## COUNCIL ASSESSMENT REPORT

### SYDNEY CENTRAL CITY PLANNING PANEL

<b>PANEL REFERENCE &amp; DA NUMBER</b>	PPSSCC- 620 DA 699/2025/JP
<b>PROPOSAL</b>	Mixed Use Development comprising Six Buildings and including 826 Residential Apartments, a Child Care Facility, Retail and Café Uses.
<b>ADDRESS</b>	Lot 3 and 4 DP 1253073 301 Samantha Riley Drive, Kellyville
<b>APPLICANT</b>	Kellyville Investments No.1 Pty Ltd
<b>OWNER</b>	Centro Holdings Pty Ltd
<b>DA LODGEMENT DATE</b>	5 November 2024
<b>APPLICATION TYPE</b>	Development Application – Nominated Integrated Development
<b>REGIONALLY SIGNIFICANT CRITERIA</b>	Section 2, Schedule 6 of the Planning Systems SEPP CIV > \$30 million
<b>CIV</b>	\$236,418,808.00
<b>CLAUSE 4.6 REQUESTS</b>	Clause 4.3 Height of Buildings – The Hills Local Environmental Plan 2019
<b>KEY SEPP/LEP</b>	<ul style="list-style-type: none"> <li>• State Environmental Planning Policy (Planning Systems) 2021</li> <li>• State Environmental Planning Policy (Housing) 2021</li> <li>• State Environmental Planning Policy (Transport and Infrastructure) 2021</li> <li>• State Environmental Planning Policy (Resilience and Hazards) 2021</li> <li>• State Environmental Planning Polic

Figure 5. Extract of LZN\_015 Land Zoning Map from The Hills Local Environmental Plan 2019

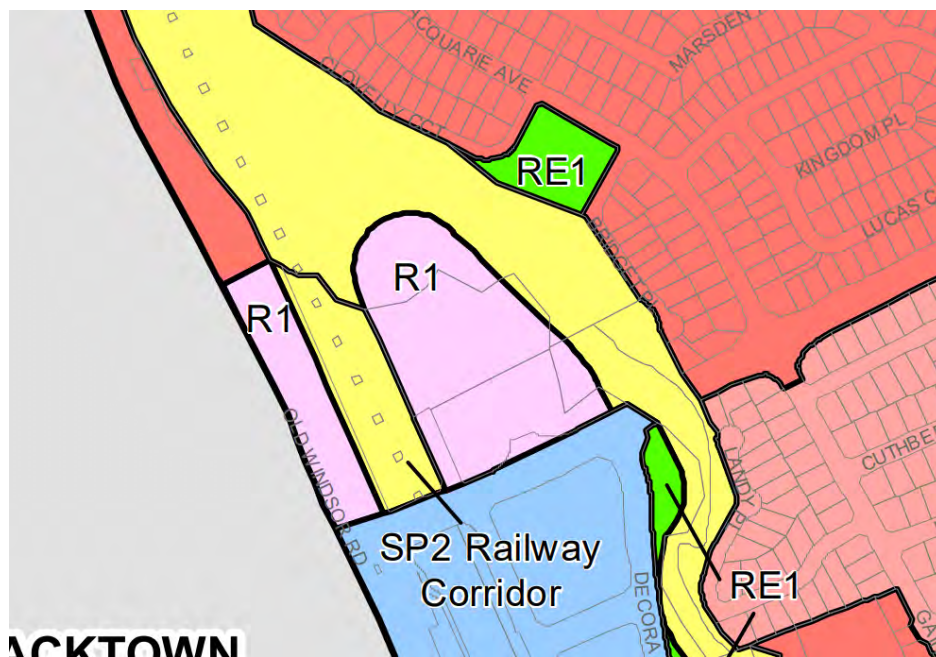
The subject site and adjoining property are zoned part R1 General Residential and part SP2 Infrastructure. The extent of the R1 General Residential Zoning envisages the development site to be amalgamated and developed in a coordinated manner. An extract of the Land Zoning Map is provided below.

Part B Section 16 – 301 Samantha Riley Drive, Kellyville of The Hills Development Control Plan 2012 also contemplates the site being amalgamated with the adjoining land to form a consolidated development site. Figure 3 from the site specific DCP illustrates this. Whilst the non-compliance with the DCP is noted, the fragmented boundaries and inefficient layout would otherwise remain as an orderly development issue and would warrant refusal.
